STAFF REPORT

RE: **501 Front Street**
(permit application # T2019-0089)

FROM: Karen DeMaria, City of Key West Urban Forestry Manager

CONCH TOUR TRAIN
RENOVATIONS
501 Front Street
KEY WEST, FLORIDA.

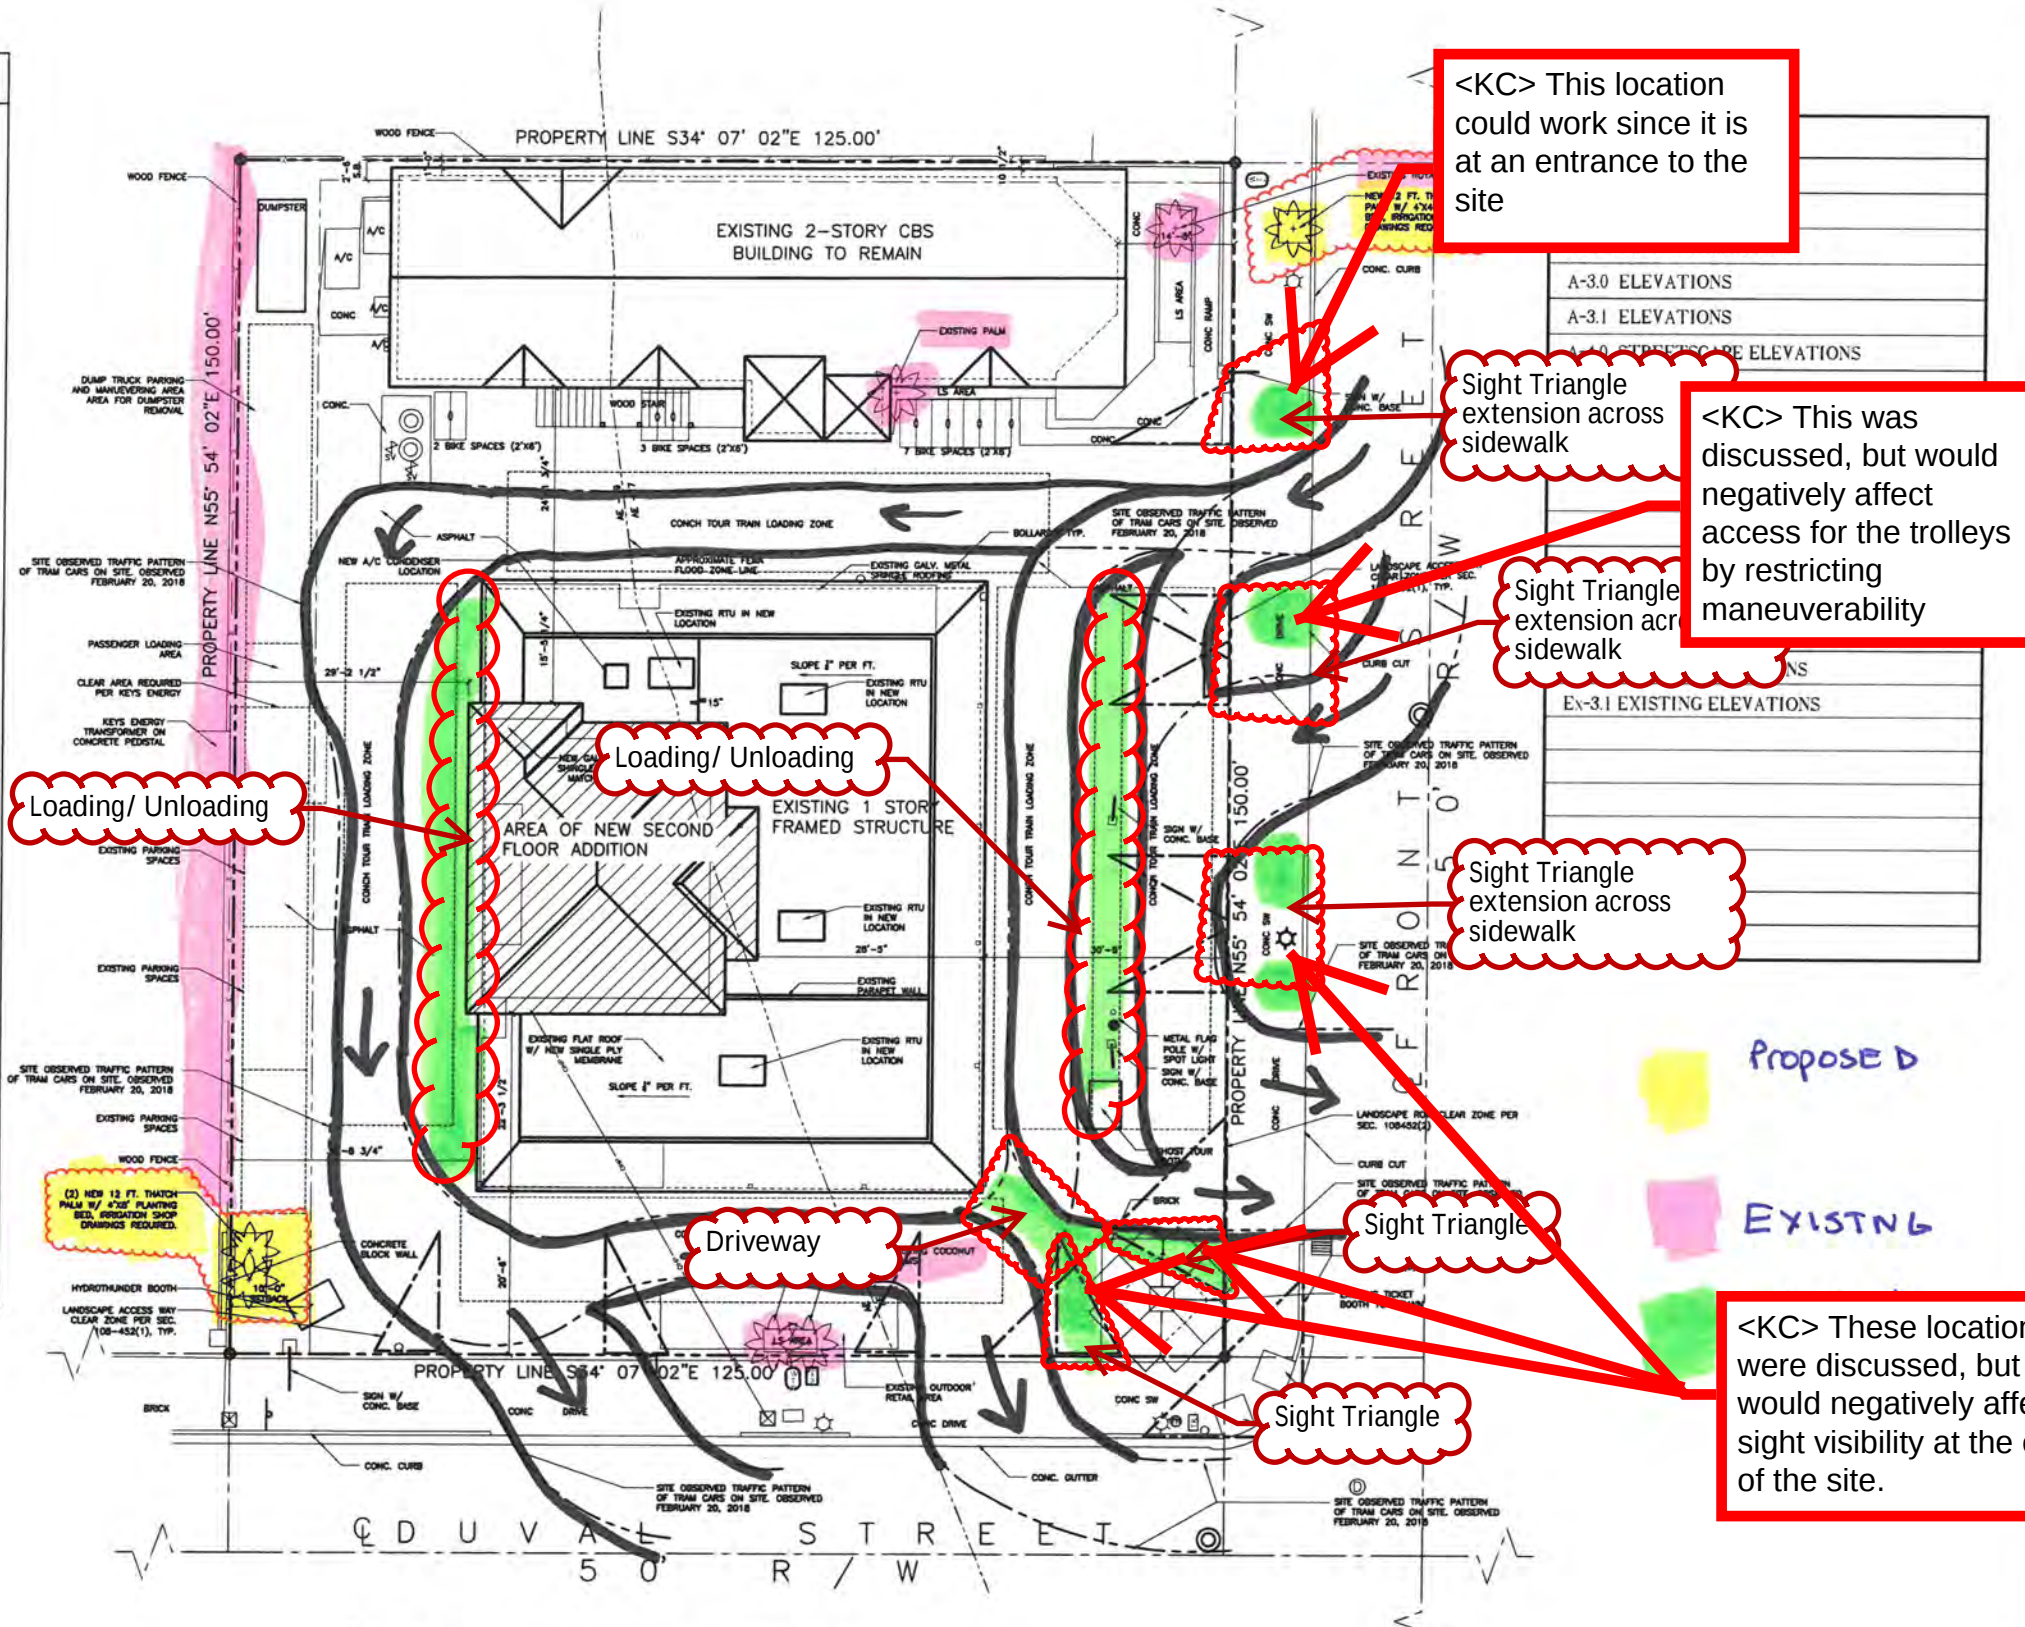
After reviewing the site for opportunities to plant trees, it appears that the operations on-site limit the ability to add trees along the frontage at Front Street. Two primary concerns were maneuverability of vehicles accessing the property and sight visibility exiting the site. During my meeting with Owen and his team, we identified an alternate approach for tree locations, two of which were shown on his plan. The easternmost "potential" tree planting site (in front of Ron Jon) was part of this approach. It looks like it may not have been implemented on this plan due to the conflict with the sight triangle; however, the access is an *ingress*, not an egress. I believe this location would be acceptable for adding a tree.

<KC> This location could work since it is at an entrance to the site

<KC> This was discussed, but would negatively affect access for the trolleys by restricting maneuverability

<KC> These locations were discussed, but would negatively affect sight visibility at the exit of the site.
